Vertical ZIF Connector
80 pin

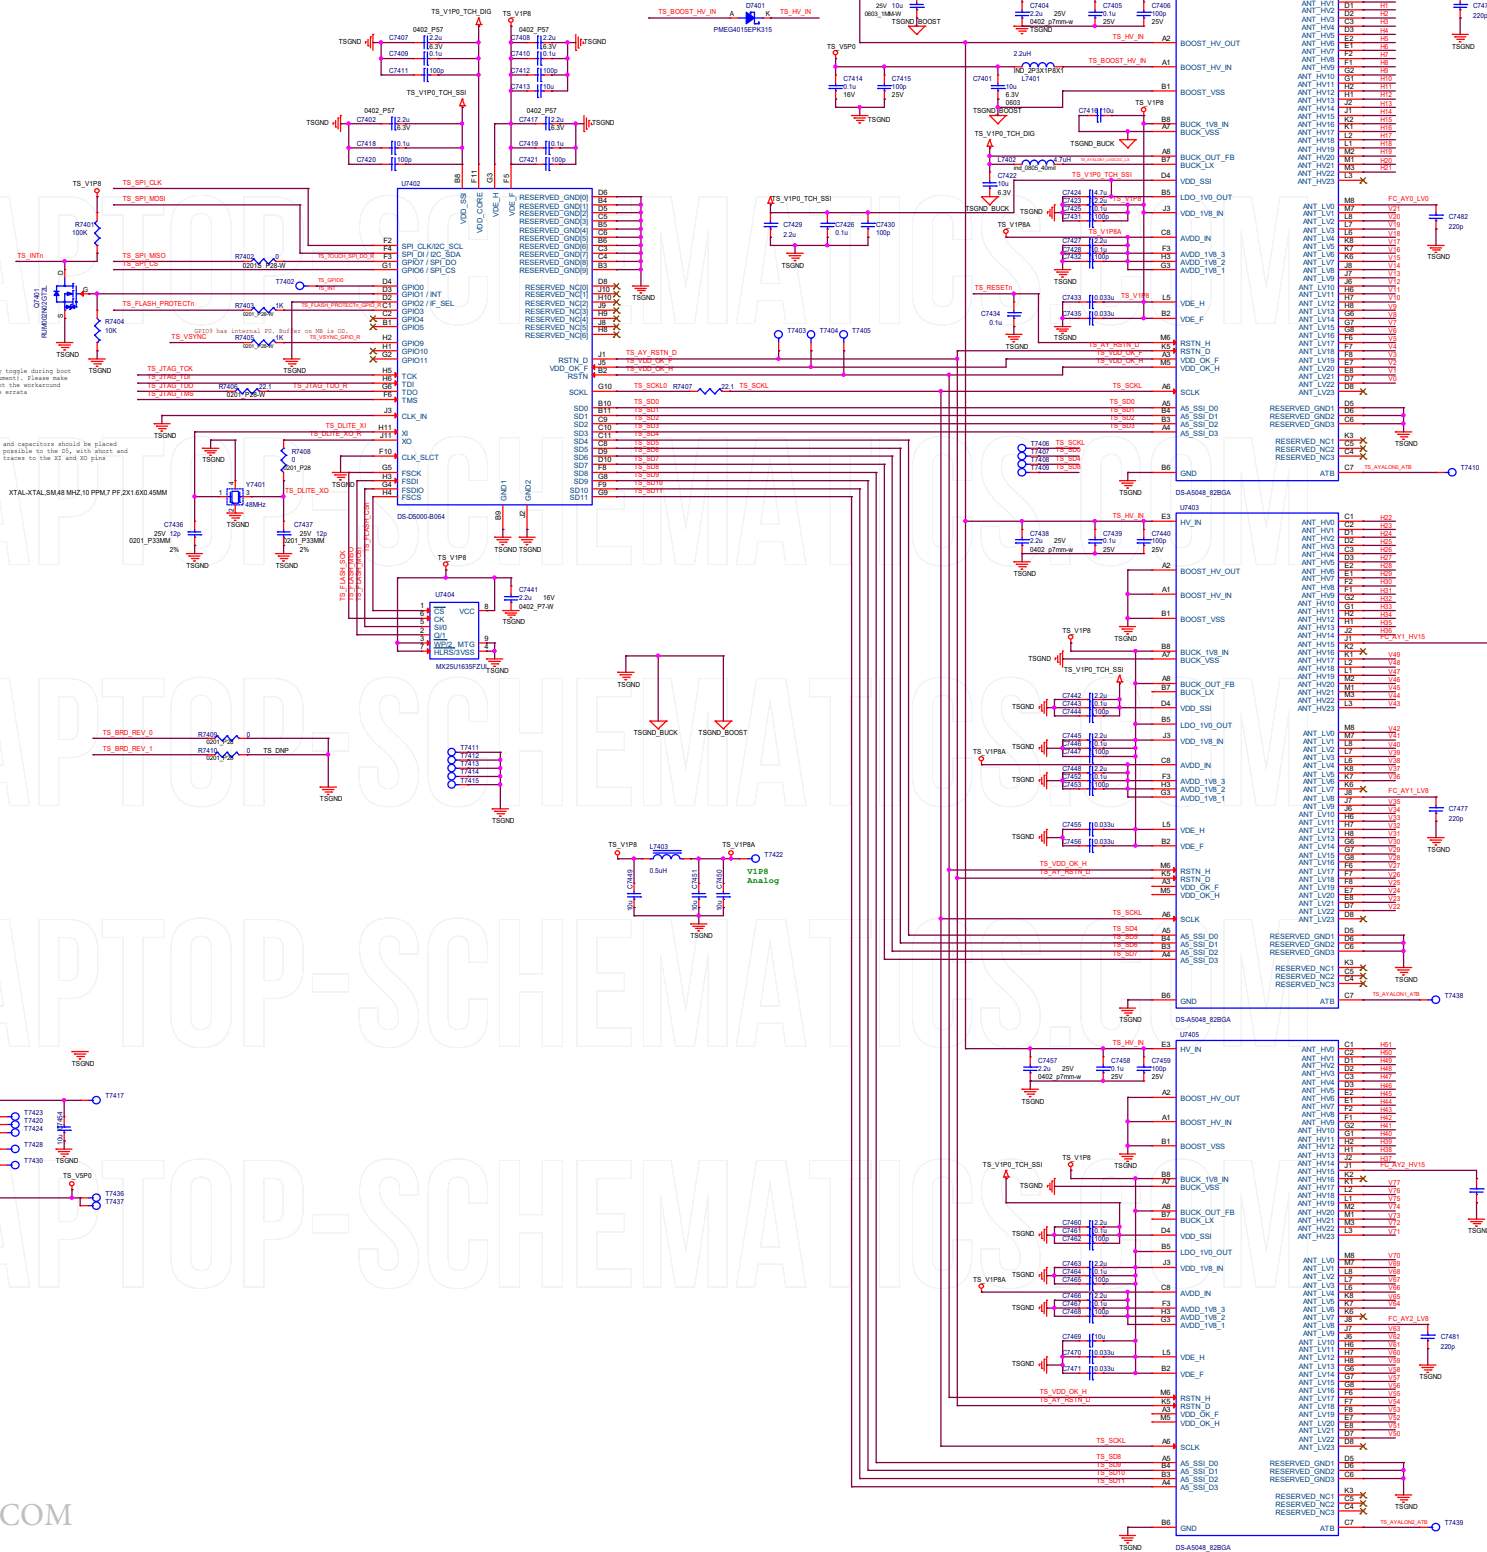
Date	Change Description
05/26/2016	Initial EV1 Release
07/12/2016	BOM change for C7472-C7485 to 330pF X7R Reduce test points. Net names for fixed caps.
08/08/2016	Remove C7473,C7474,C7476,C7478,C7483,C7484,C7485. BOM change C7472,C7475,C7477,C7479,C7481,C7482 to 220pF NPO.
09/12/2016	Update Shield Frame to EV2 part
10/15/2016	R7402 to 0 ohm for faster rise time
10/31/2016	L7401 to higher current saturation
